**TOWN OF NEWBURGH  
PLANNING BOARD  
TECHNICAL REVIEW COMMENTS**

**PROJECT NAME:** NEWBURGH ELITE SELF STORAGE  
**PROJECT NO.:** 24-12  
**PROJECT LOCATION:** SECTION 34, BLOCK 2, LOT 34  
**REVIEW DATE:** 28 OCTOBER 2024  
**MEETING DATE:** 7 NOVEMBER 2024  
**PROJECT REPRESENTATIVE:** LANC & TULLY/JOHN QUEENAN P.E.

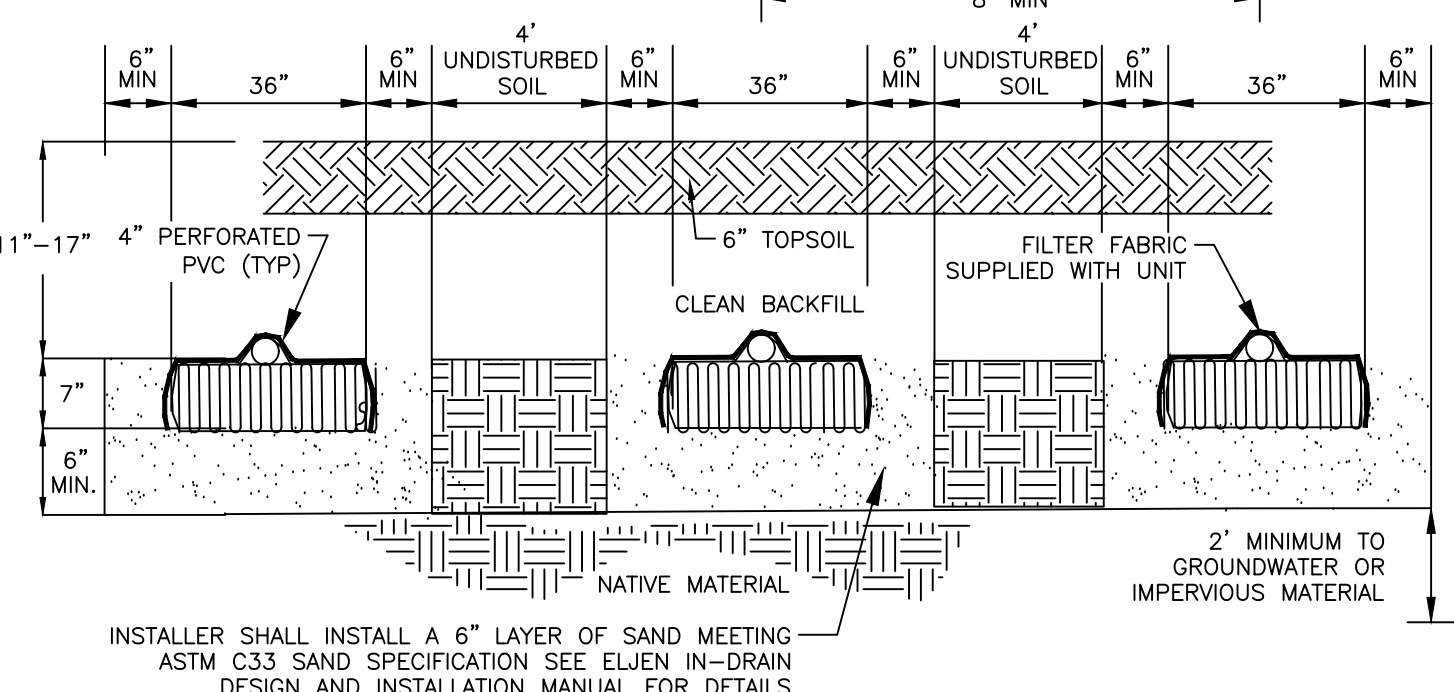
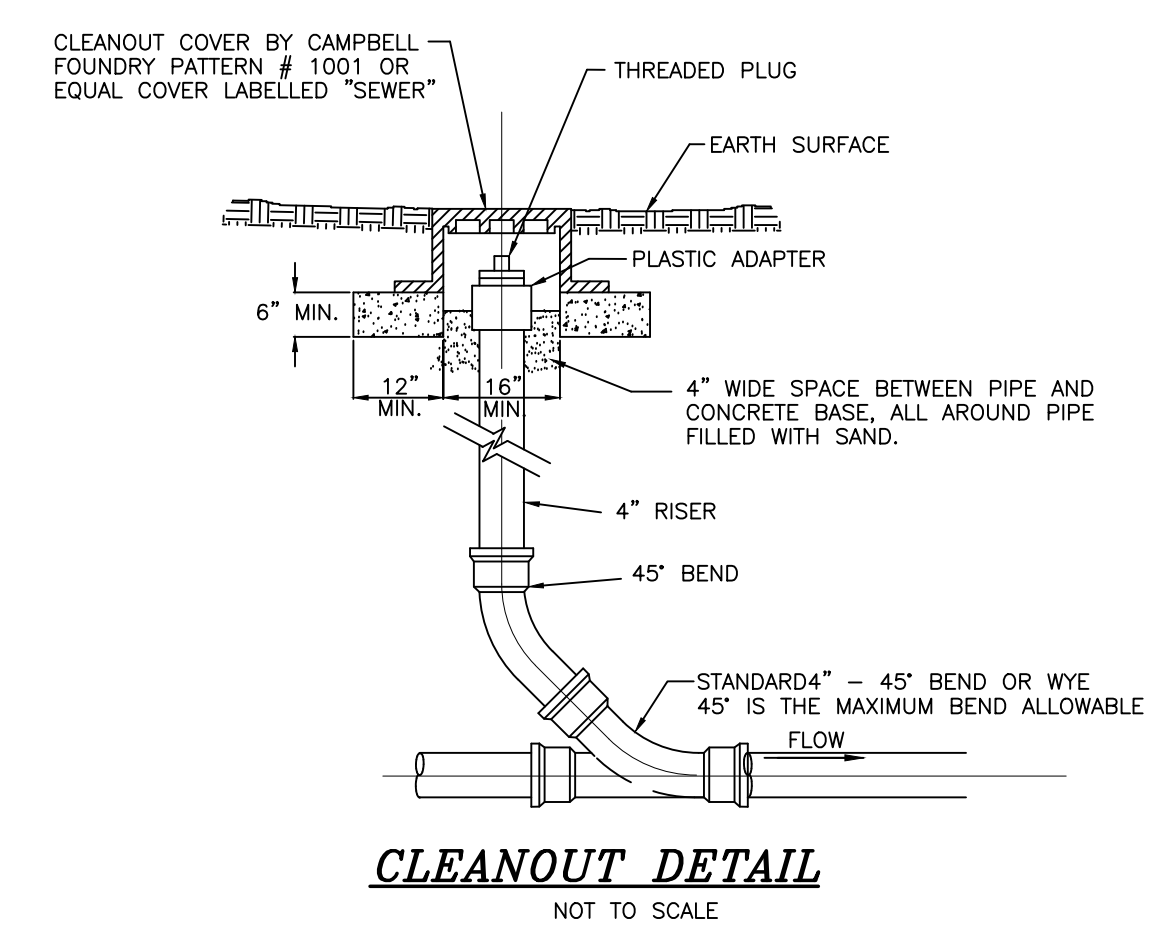
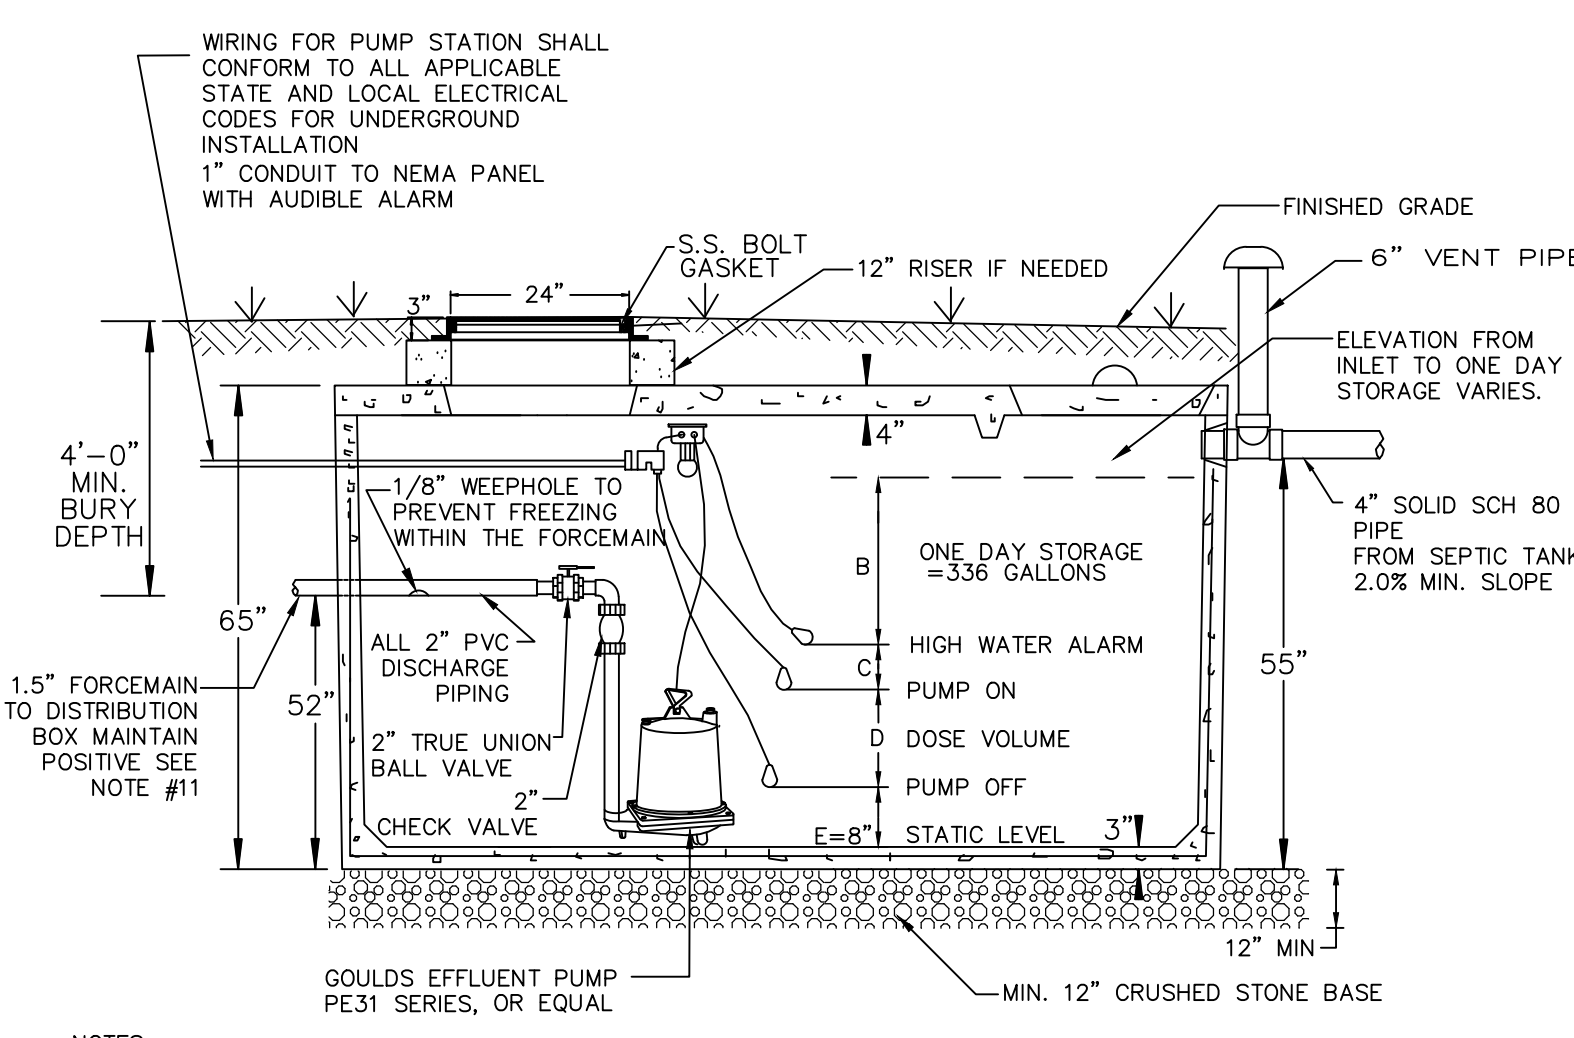
7. The 1,000 septic tank detail should be added to the plan sheet.
8. A pump station alarm should be addressed.
9. Septic system notes should identify that as-built plan must be submitted with the certification prior to issuance of a certificate of occupancy.

LANDSCAPING PLAN AND DETAILS  
PREPARED FOR

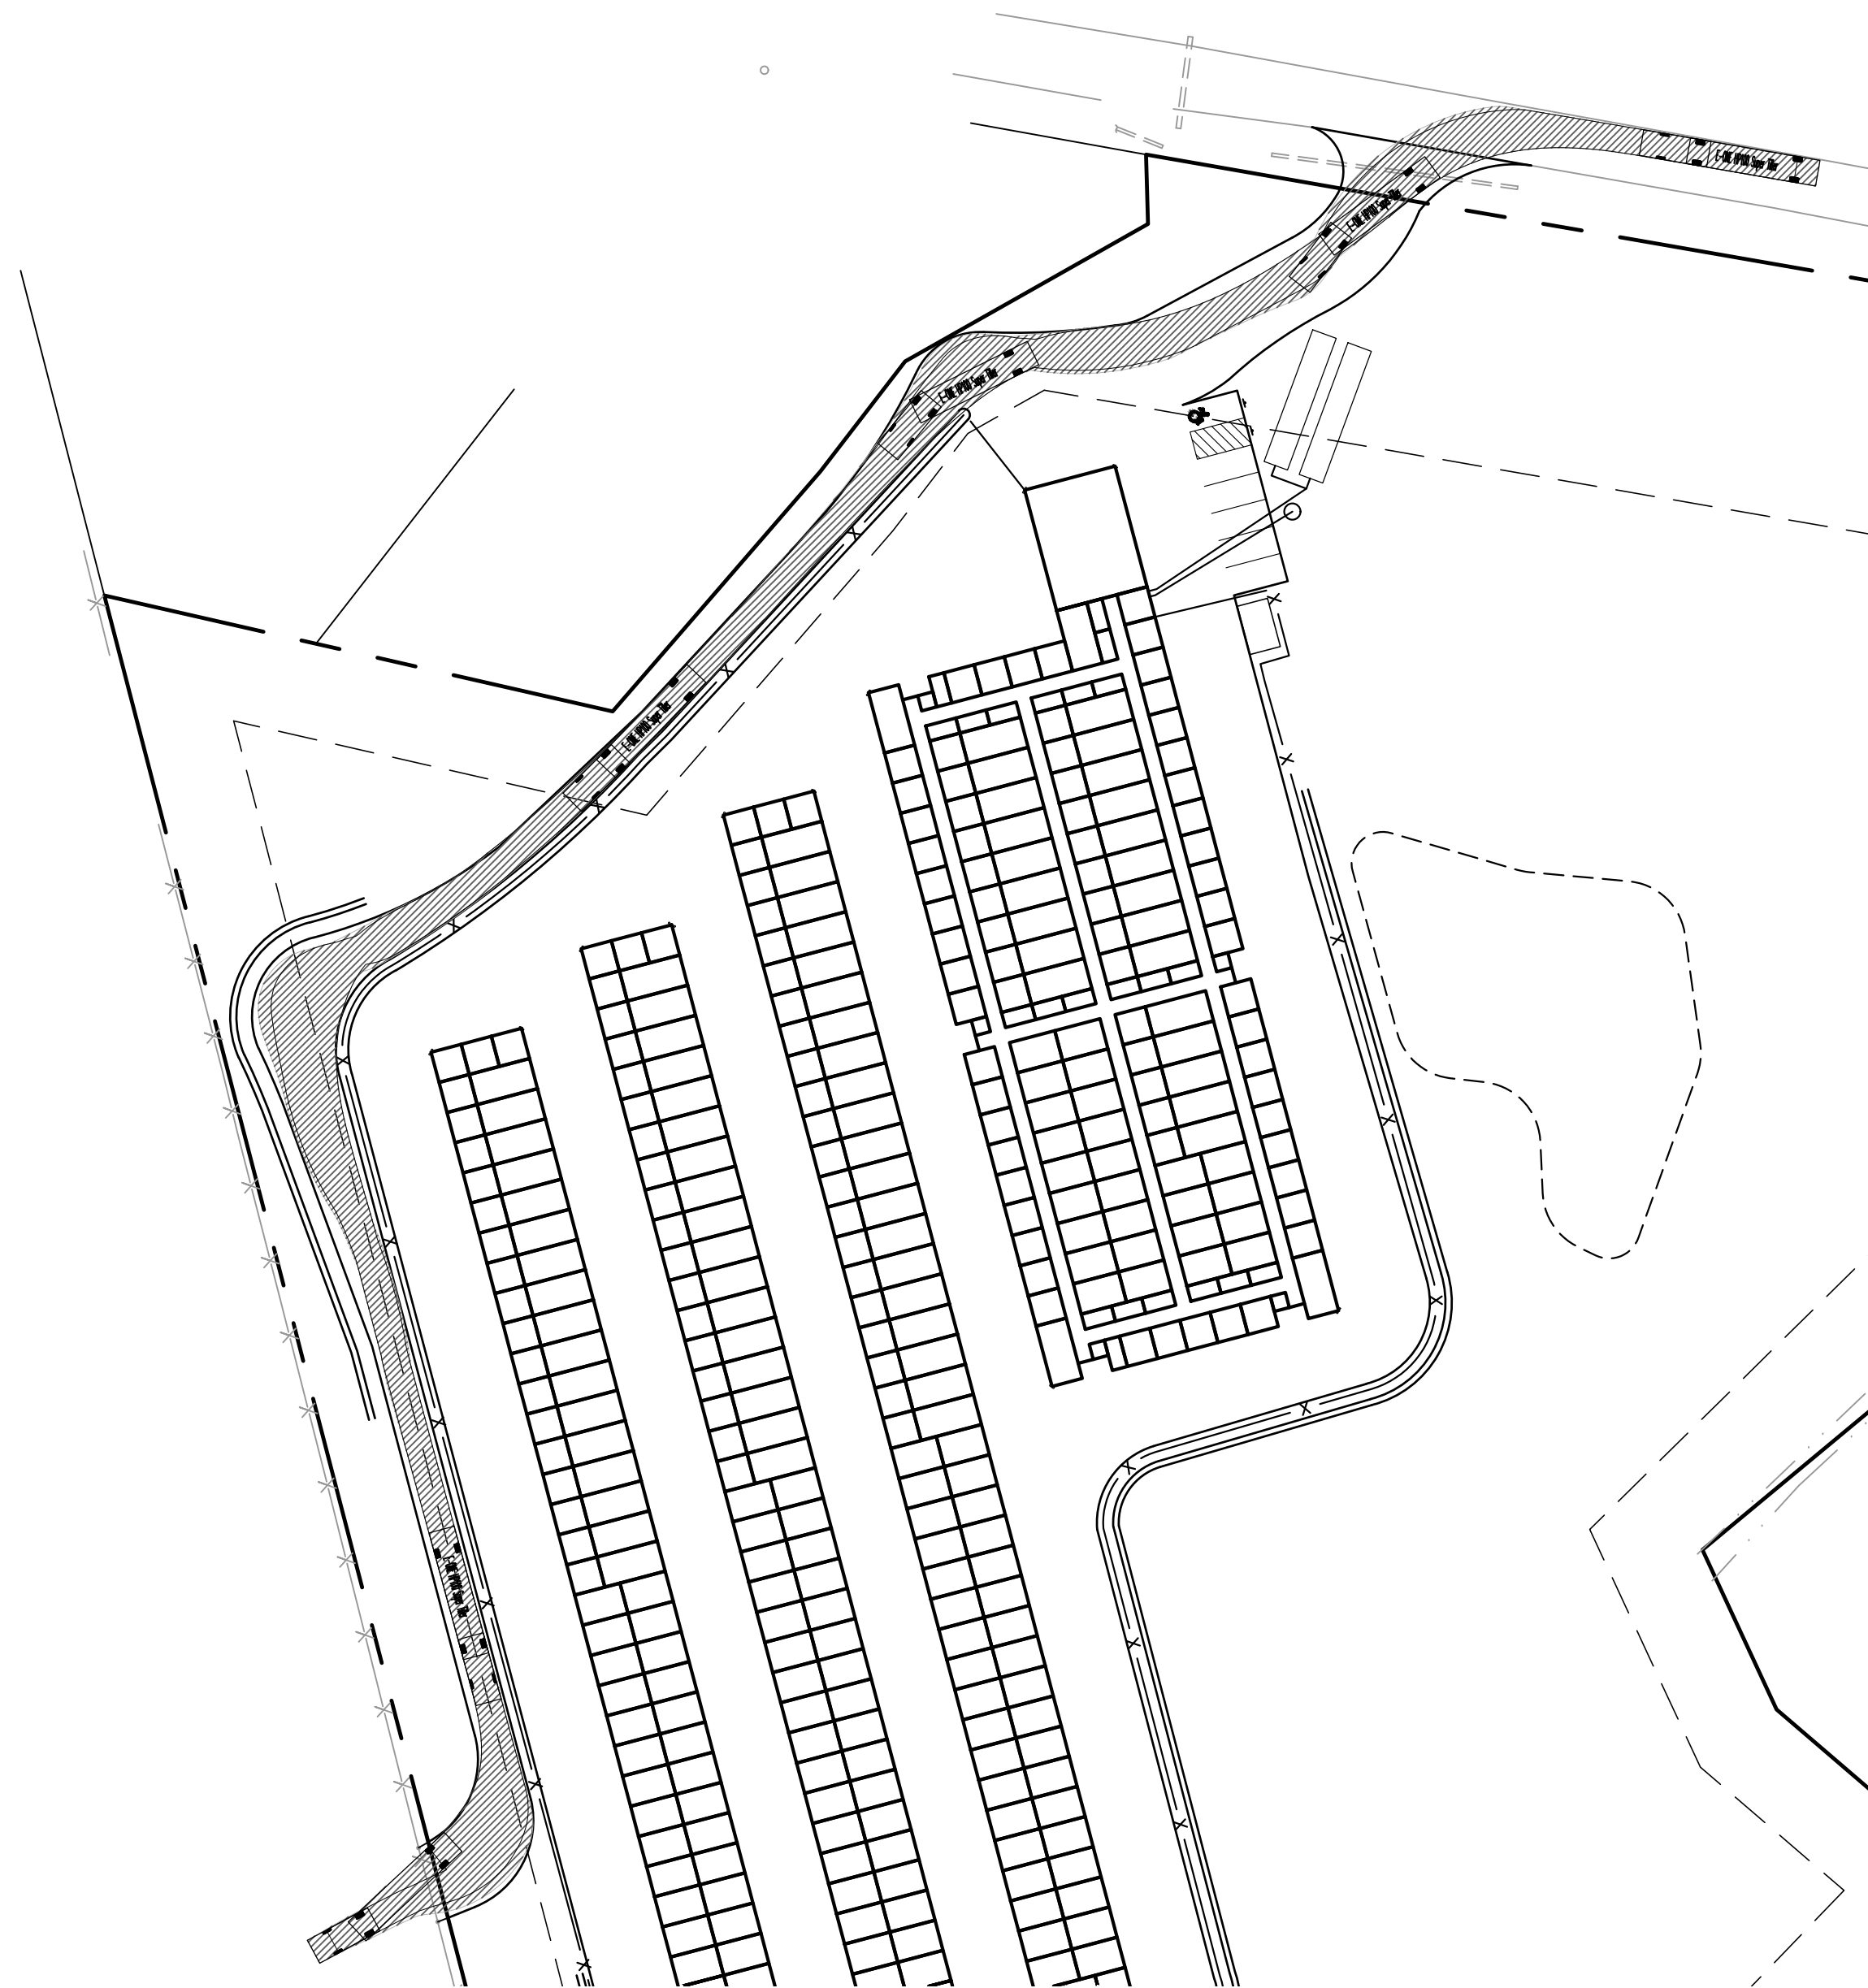
18. Landscaping plan should be further developed identifying the location, number, of any proposed landscaping. Landscaping plan should address the entrance at Paffendorf Road.

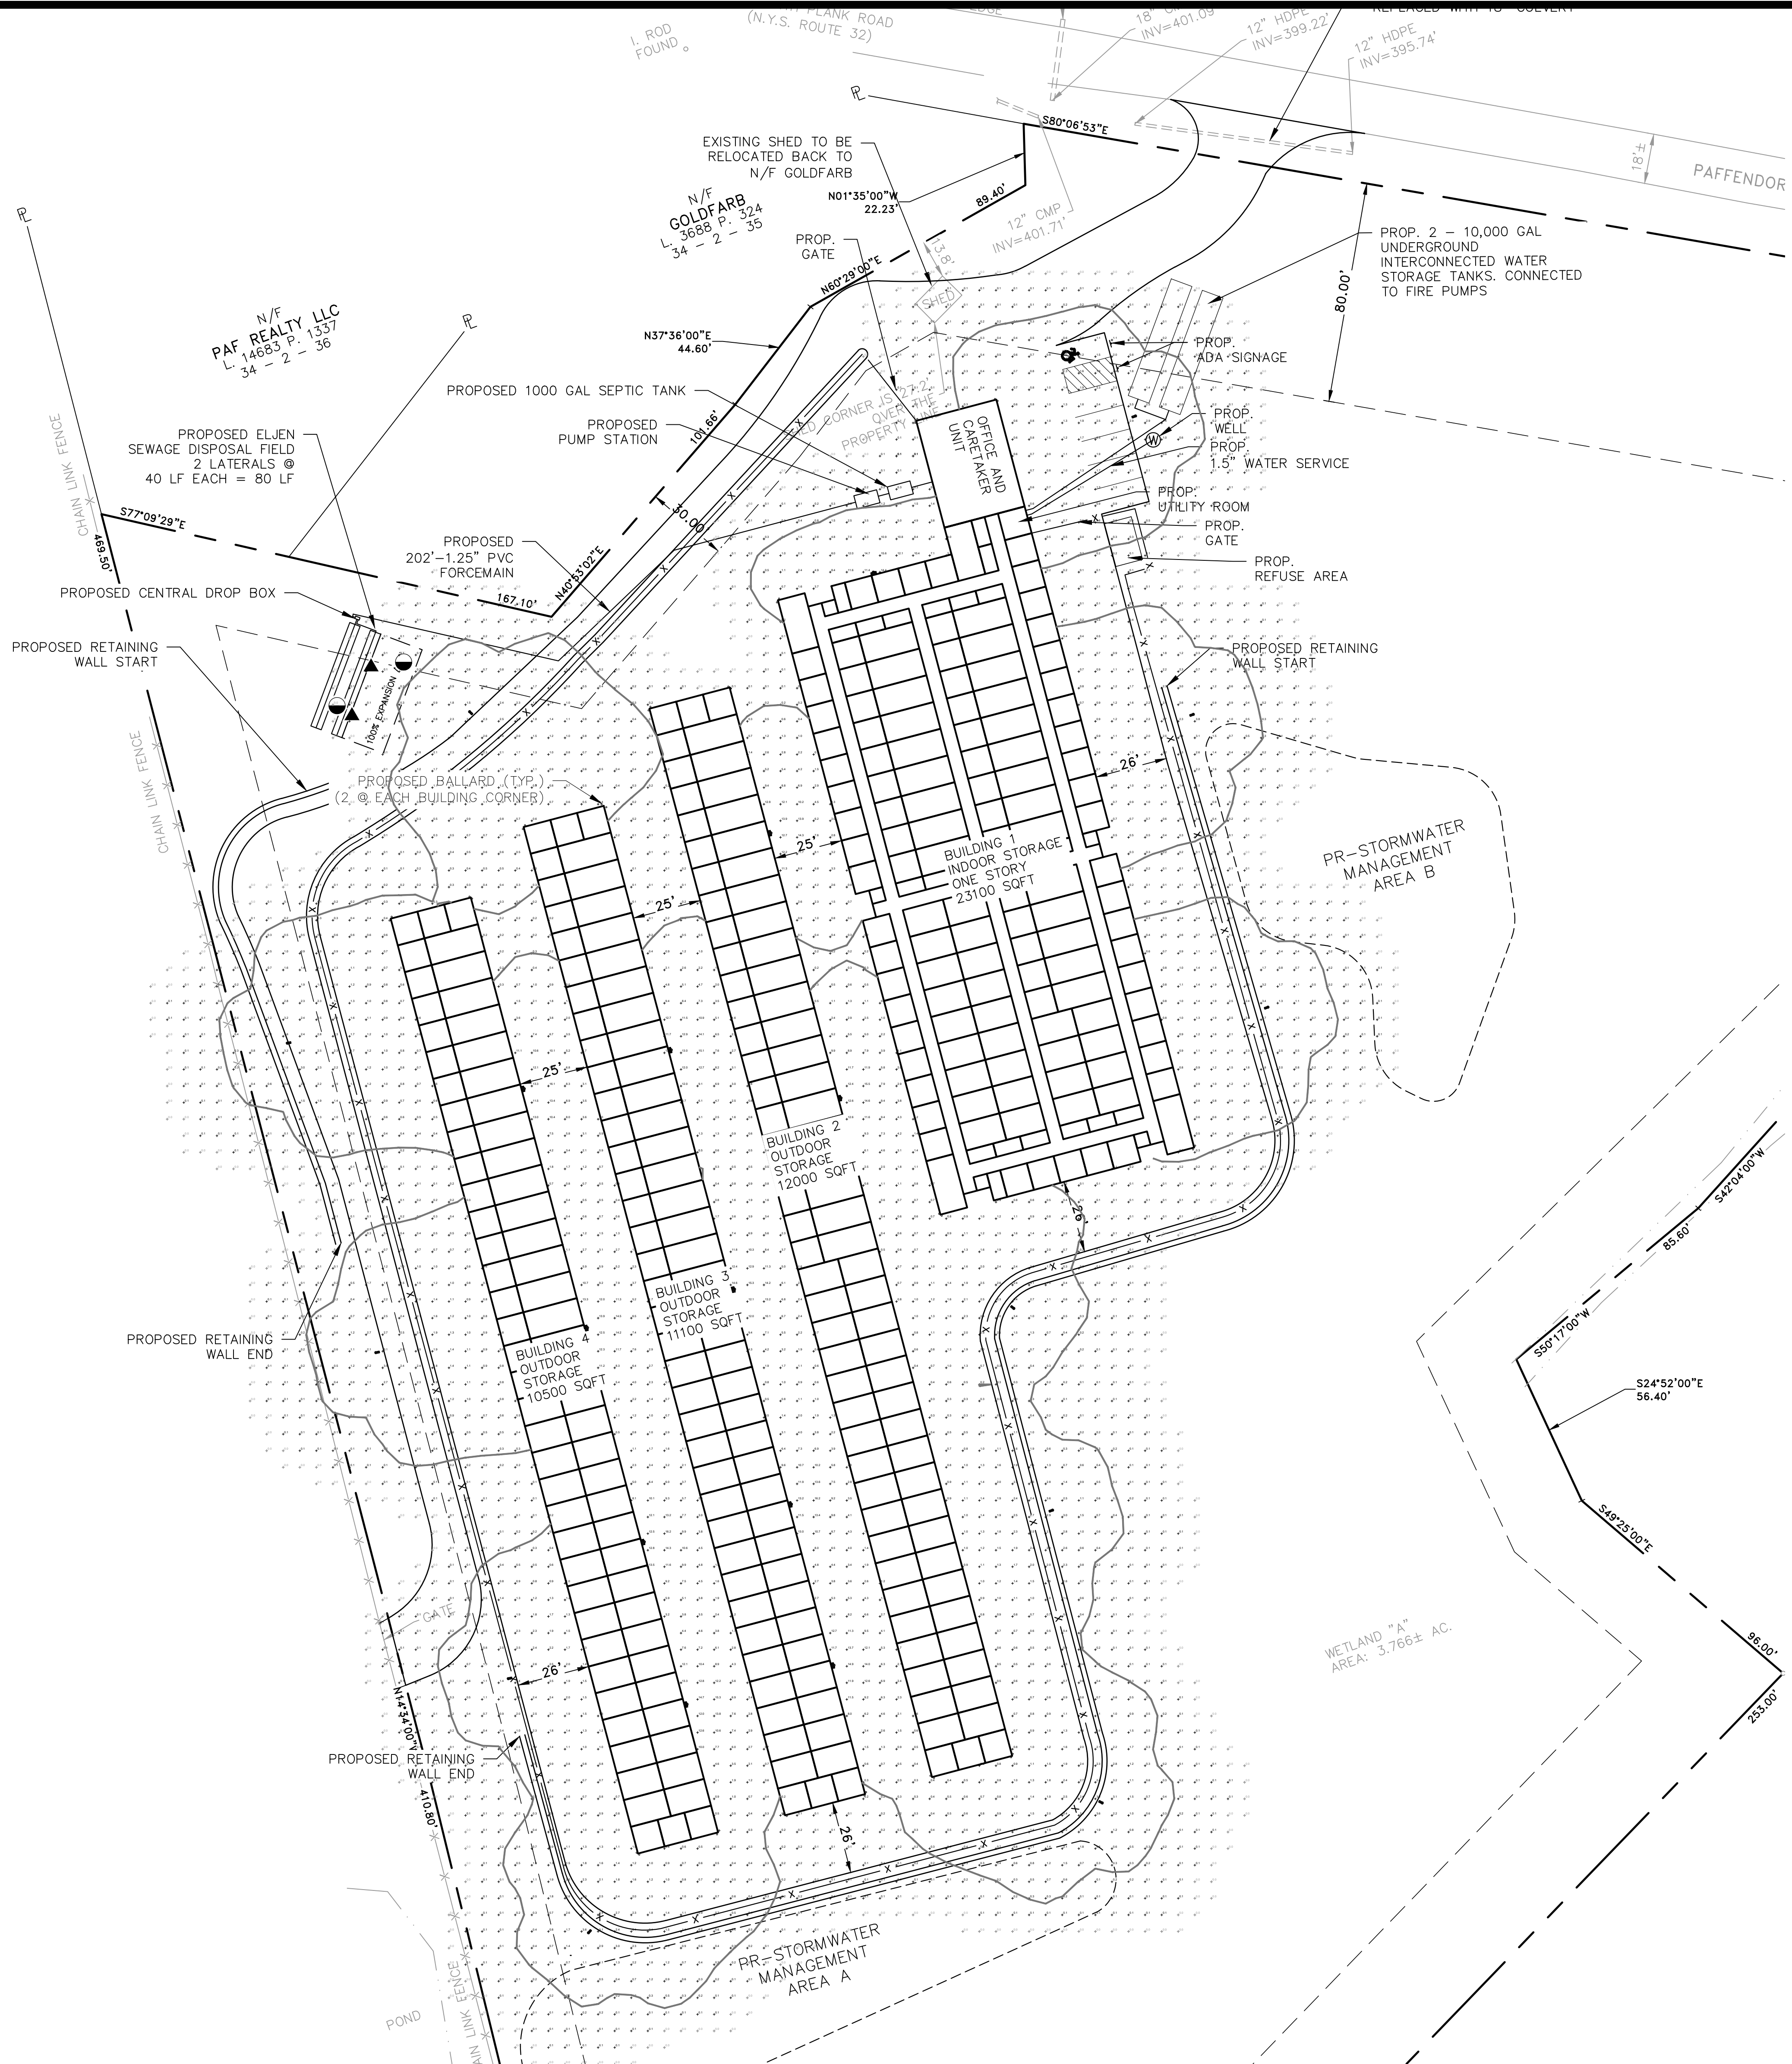
10. The location for the building mounted and pole mounted lighting should be depicted on the lighting plan. It is noted that the pole mounted lights are identified as 17 foot mounting height.
